March 19, 2004

From: Garrett Stone

**Comments on January 23, 2004 Draft “Analysis Results for
Performance Based Ratings for the Energy Star Windows Program”
from LBNL**

Figure 1 -- IECC Replacement Window Climate Zones

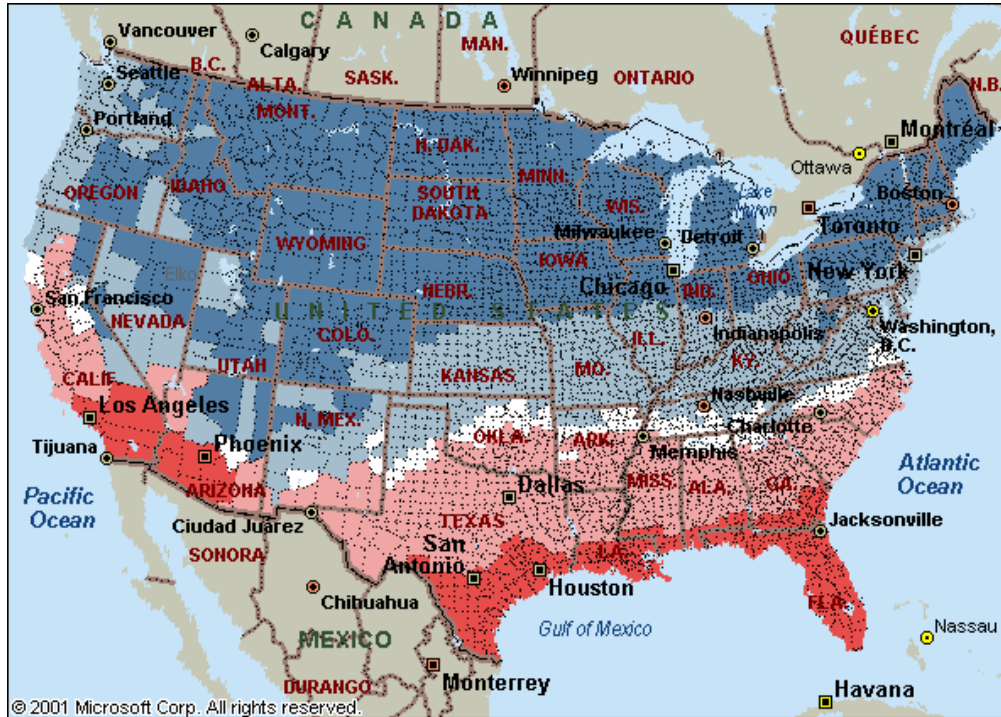
Recommendation # 1: We suggest that the report refer to and incorporate the map and information in Figures 1 and 2 below. This info should also be spelled out clearly in the Executive Summary.

- There can be no north zone trade-off involving U-factors above 0.35.
- There can be no north central trade-off involving U-factors above 0.40.
- There can be no south central trade-off involving either U-factors above 0.50 or SHGCs above 0.40.
- There can be no south zone trade-off involving U-factors above 0.75 or SHGCs above 0.40.
